**Wickenburg Downtown Flooding Hazard
Mitigation Project
(FCD #2006C018)
CLOMR
FEMA Case No. 07-09-0738R**

**Response to
FEMA Review Comments of
April 17, 2007**

IN REPLY REFER TO:
Case No.: 07-09-0738R

Legend

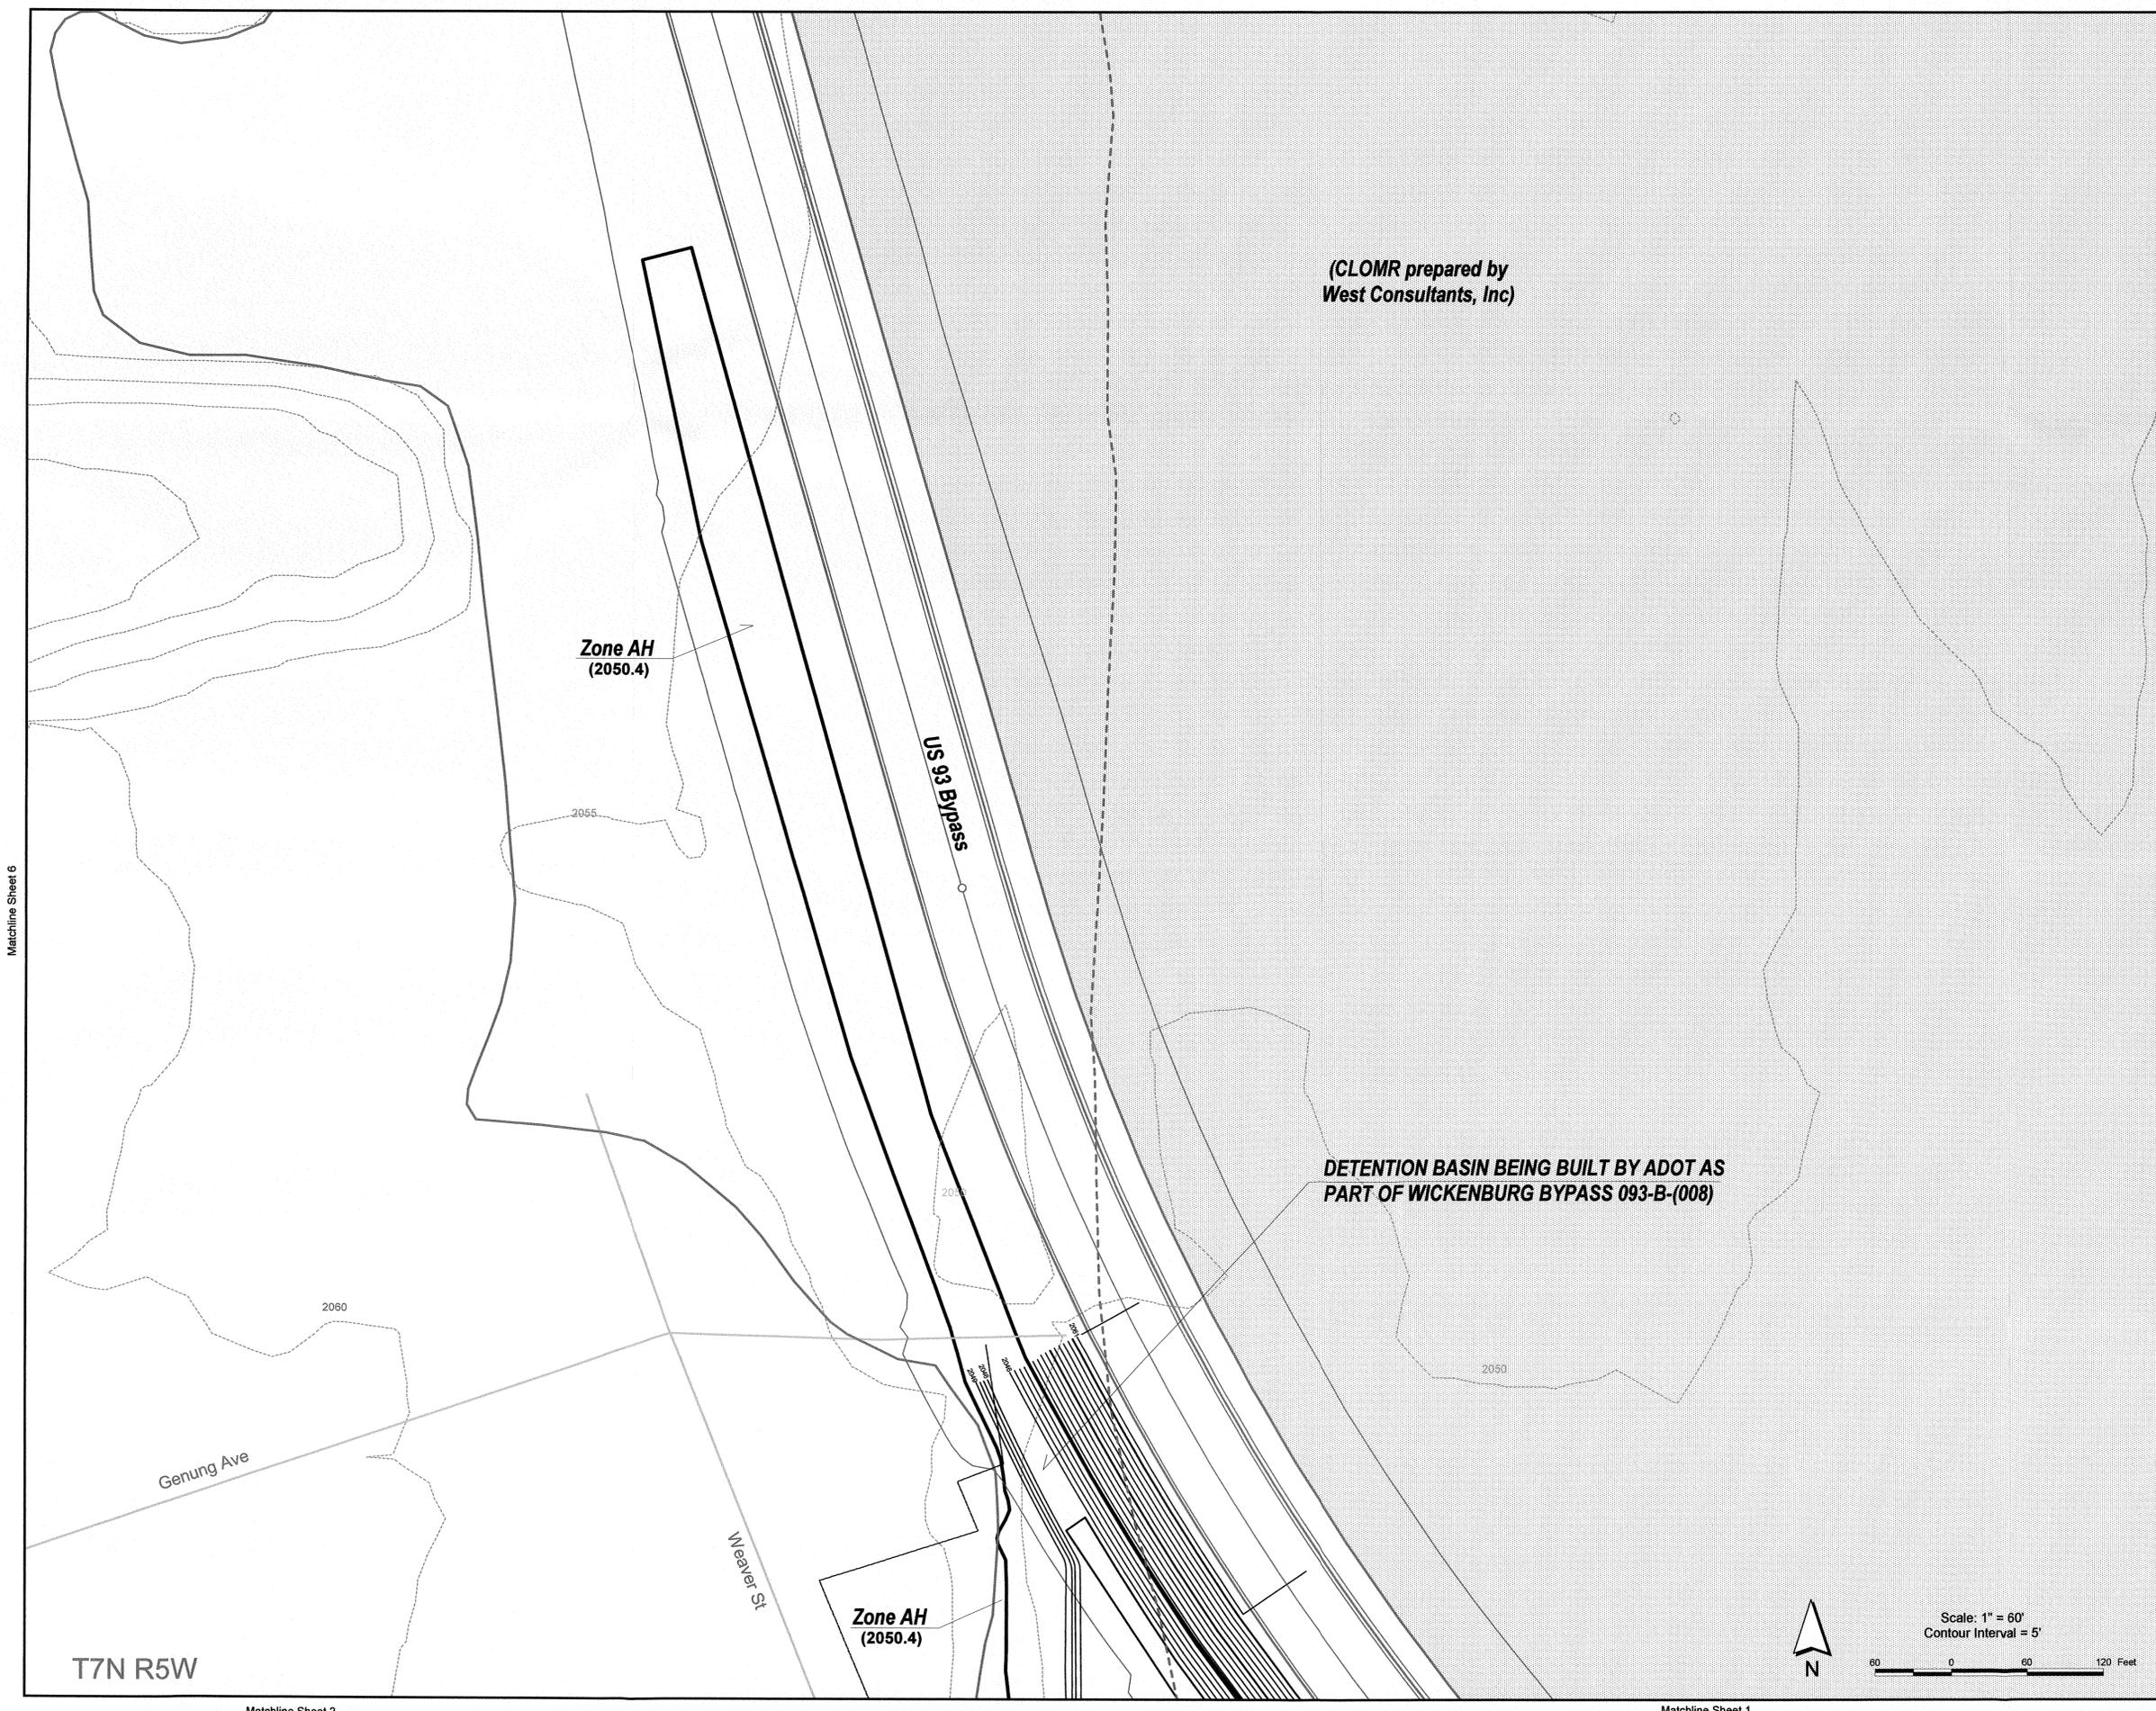
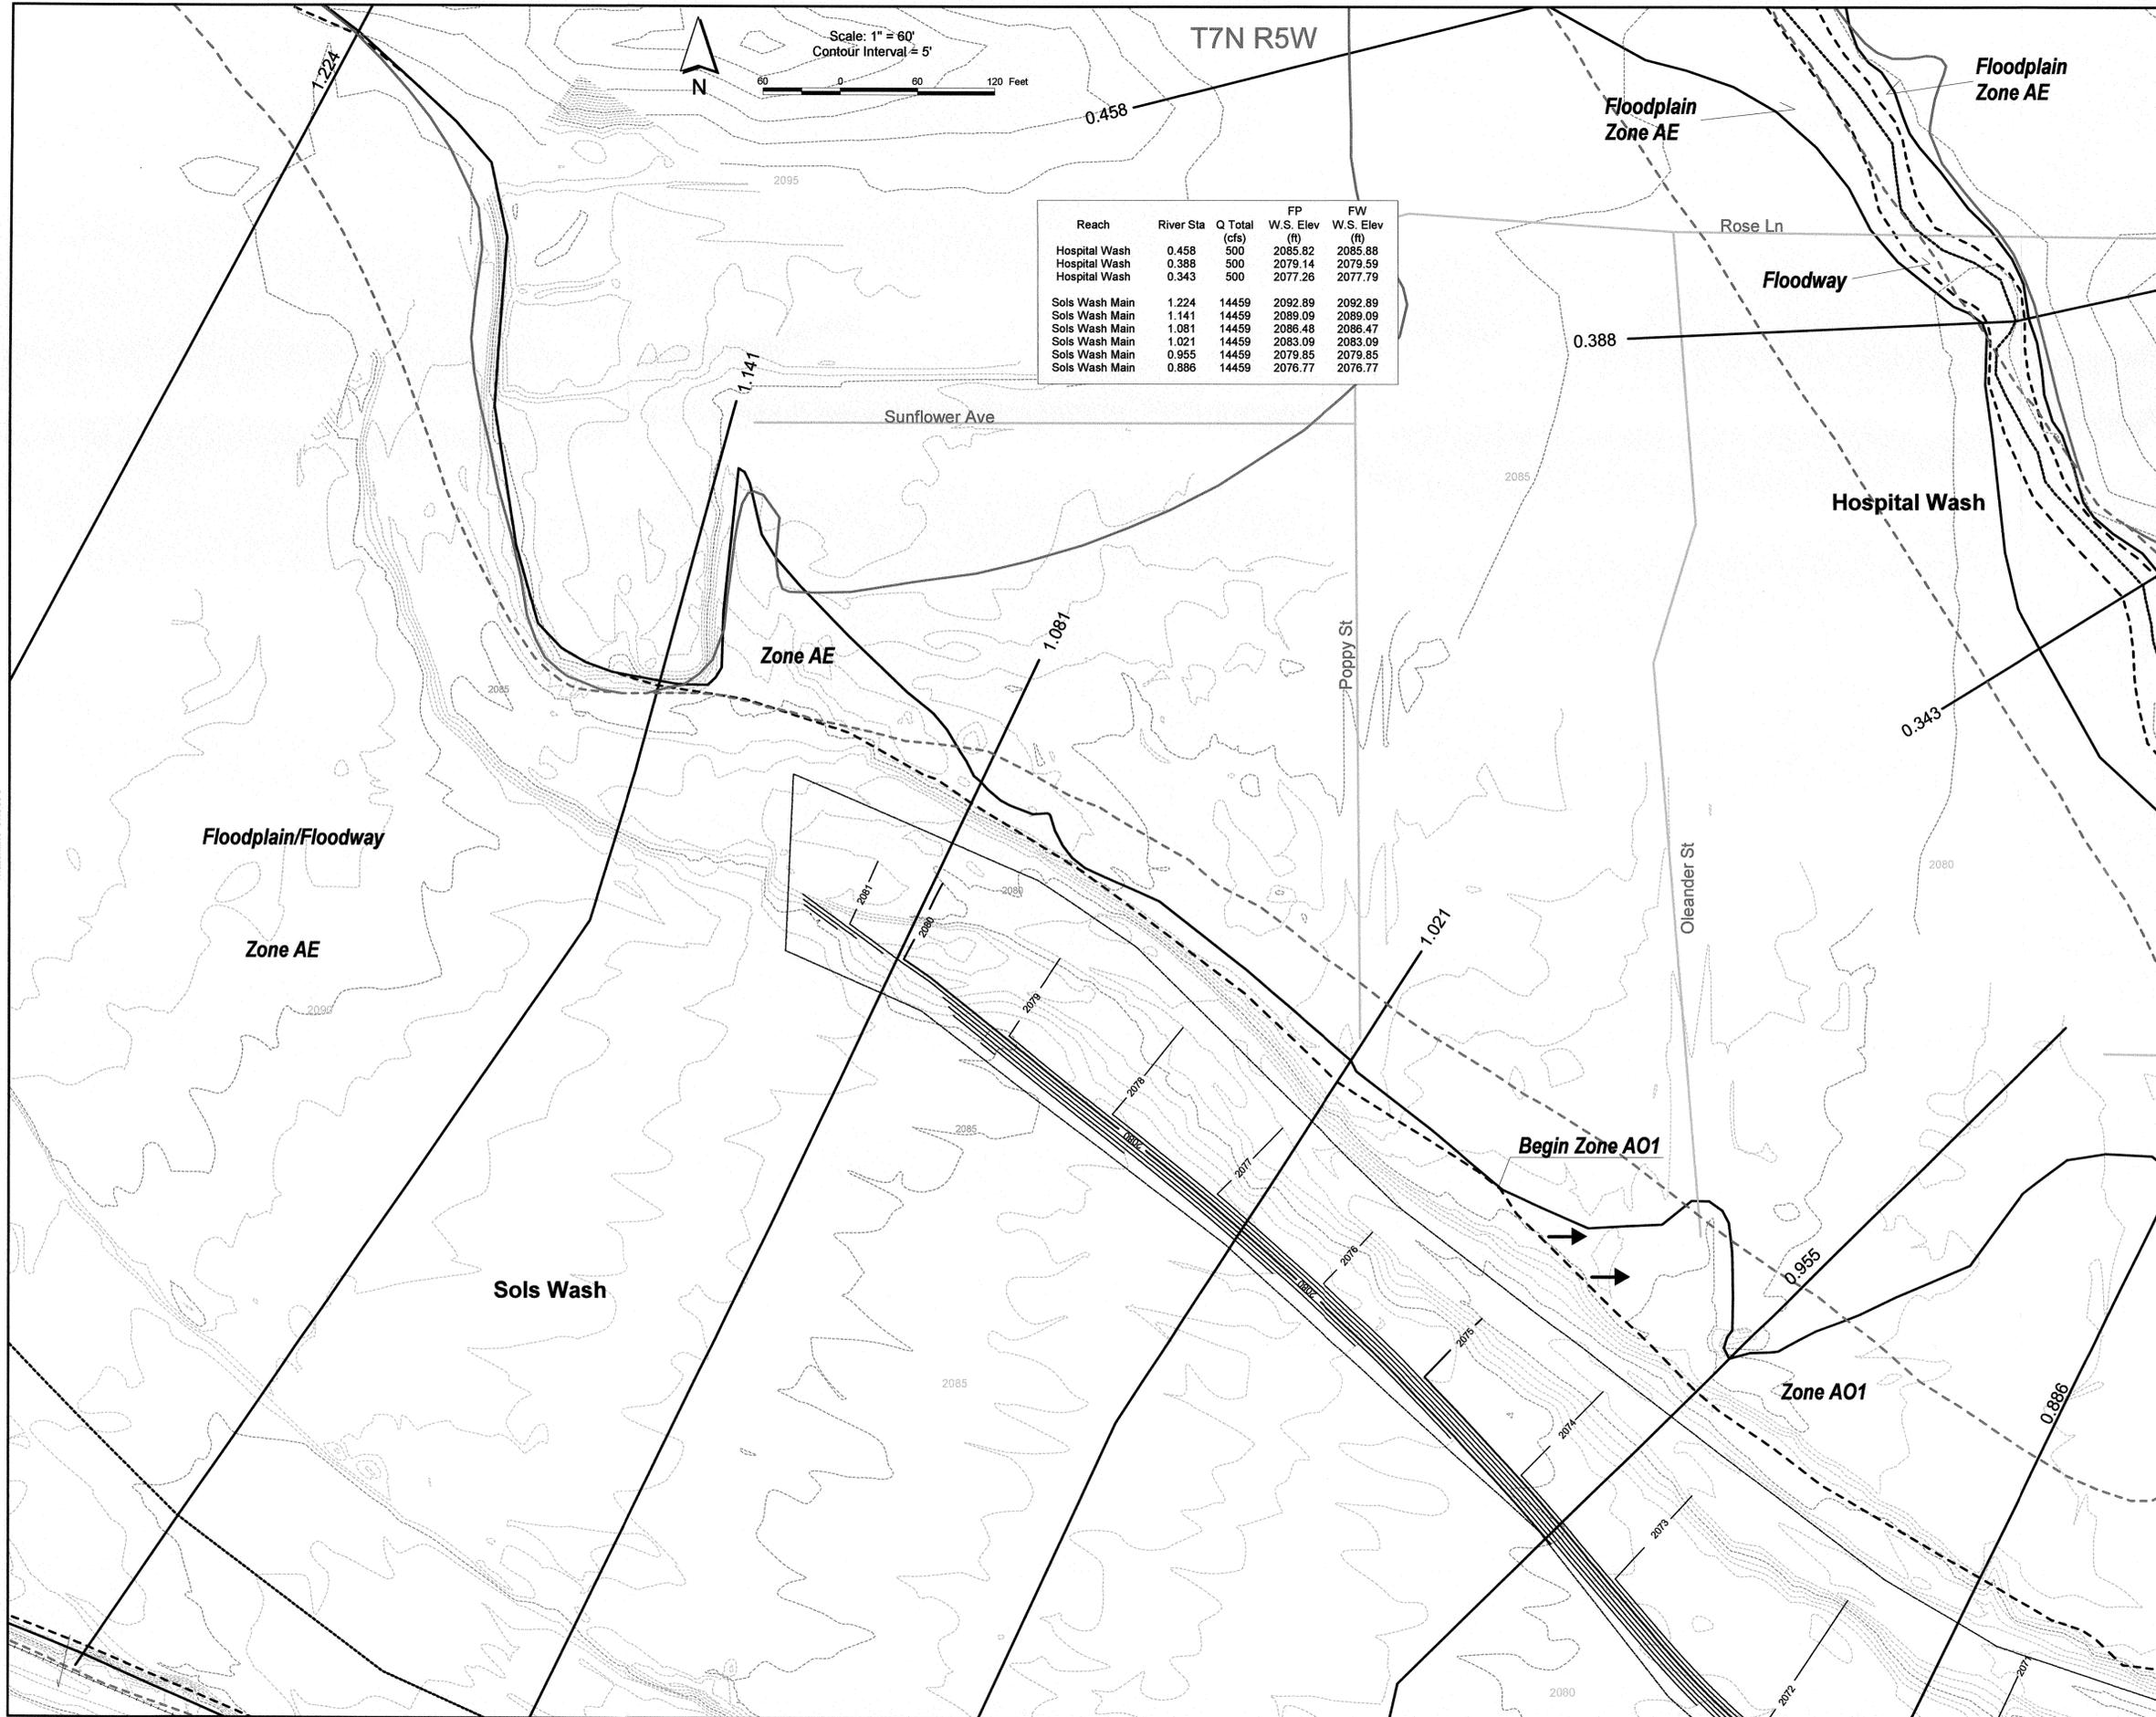
9. The above-mentioned topographic work maps do not provide essential information required to complete our detailed review of this request. Please provide the following information, which was omitted from the submitted topographic work maps.

- (a) Boundary delineations of the currently effective base floodplain and floodway
- (b) Boundary delineation of the existing conditions base floodplain
- (c) Existing conditions topographic contour information, including the topographic information that has been altered by the existing floodwall and Goldmine Village improvements
- (d) Proposed conditions topographic contour information, including topographic information that will be altered by the proposed levee, which can be used to verify the boundary delineation of the base floodplain
- (e) Please submit both a hard copy and a digital copy of all work maps

9. Revised work maps are enclosed.
 - a) The effective floodplain/floodway limits have been added to the workmaps.
 - b) The existing conditions floodplain was not studied under this project as the overall intent of this project is to channelize the Sols Wash floodplain, thereby, greatly reducing the limits of the floodplain. Based on topographic information developed for this study and that for the original FEMA study for Sols Wash, however, there is no reason to expect any significant difference between a current "existing" conditions floodplain and that of the effective study. The only exception to this is in the north overbank area where flows on the west side of Tegner Street are likely to cross over the roadway into the north overbank area on the east side of Tegner St. This is not reflected in the effective delineation even though the original FEMA study workmaps indicated that flow elevations were such that 100-YR flows might overtop Tegner St. An existing conditions study, which addressed the flows overtopping Tegner, was performed under the Goldmine Village request for a CLOMR, submitted to and approved by FEMA.

per the CLOMR. Some additional fill is required on the site to meet the CLOMR geometry. The Wickenburg Downtown Project will provide that fill. The proposed grading for the property has been added to the workmaps. The existing conditions topo shown on the submitted work maps is as the site currently exists today. Pre-fill topographic data is available in the Goldmine Village CLOMR. Please note: there is no existing floodwall on the Goldmine Village property.

- d) Proposed topographic contours have been added to reflect the proposed fill on the Goldmine Village property. Additional contours have been added where practical. Please note, in areas of vertical floodwalls, contours cannot be shown. In these areas, please refer to the cross section plots. Some revisions, to correct some minor discrepancies, have been made to several of the cross section sheets since the original submittal. Please see the revised plots in the design plan set.
